▲ Revised May 2005. This bulletin supercedes the previous bulletin with the same title dated February 2005.

OFFICIAL RECALL NOTIFICATION U.S. FEDERAL BOAT SAFETY ACT - SHIFT LINK BAR CONTACT WITH THE BACK COVER OF BRAVO X / XR DRIVES

Model	Serial Number Range
Bravo XR I / III Drives	0W240000 through 0W240652
Bravo XR I Drives with Sportmaster Gear Case	0M906878 through 0M907375

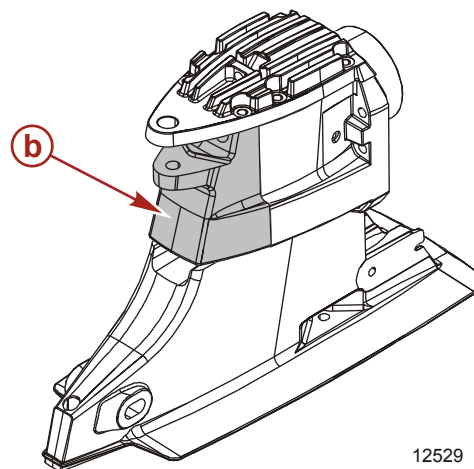
This bulletin does not apply to Integrated Transom System (ITS) models or any aftermarket installed rear cover that has steering or tie bar attachments as an integral part of the rear cover.

a - Rear cover affected by this bulletin

b - Integrated Transom System rear cover - not affected by this bulletin

New cover with added link bar clearance

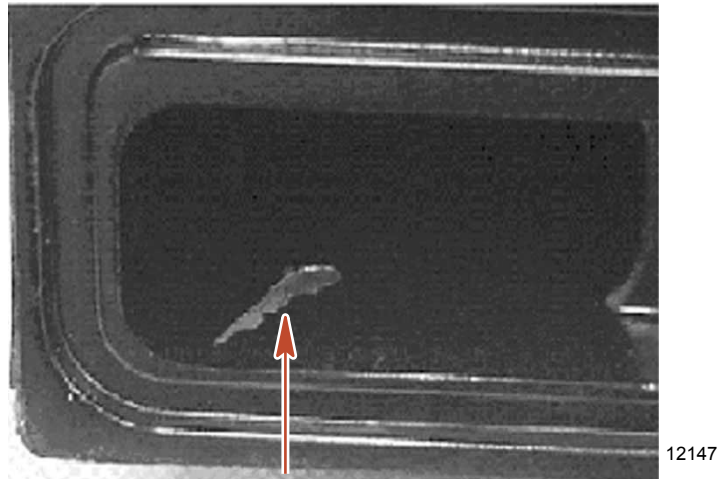
The shift link bar at the shift lever is making contact with the back cover of the driveshaft housing. The contact may cause the cotter pin to wear through, allowing the link bar to become disengaged from the shift lever, resulting in loss of shifting control. In right-hand rotation models it is also possible that the cone clutch could be prevented from engaging properly into the gear socket, resulting in the cone clutch being stuck in gear.

Contact area from link bar

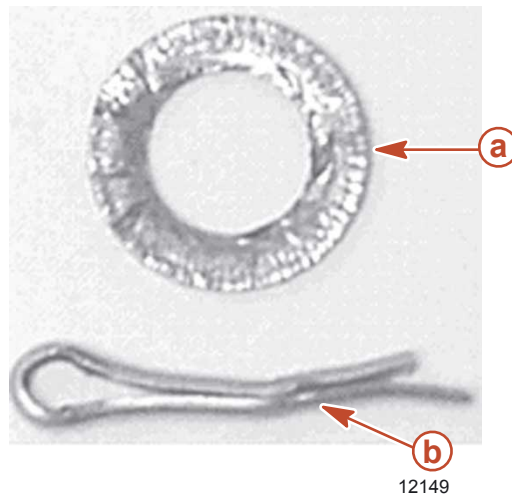
If the drive unit has been operated 30 hours or more, inspect the washer on the link bar for indentation marks from the cotter pin. If there are indentation marks on the washer, change both the washer and the cotter pin before installing the new rear cover.

a - Area of indentation marks on the link bar washer

b - Wear area on the link bar cotter pin

a - Washer and cotter pin

1. To inspect, the back cover must be removed from the drive and checked for evidence of contact from the shift link bar at the cotter pin area of the shift lever. The washer and cotter pin must also be inspected for any indentation marks on the washer from the cotter pin caused by heavy contact.
2. Replace the washer and cotter pin if required, then install the new back cover and seal from the replacement back cover kit. Using Special Lubricant 101, lightly grease the new detent ball canister and spring assembly and place it into the new back cover before installation.
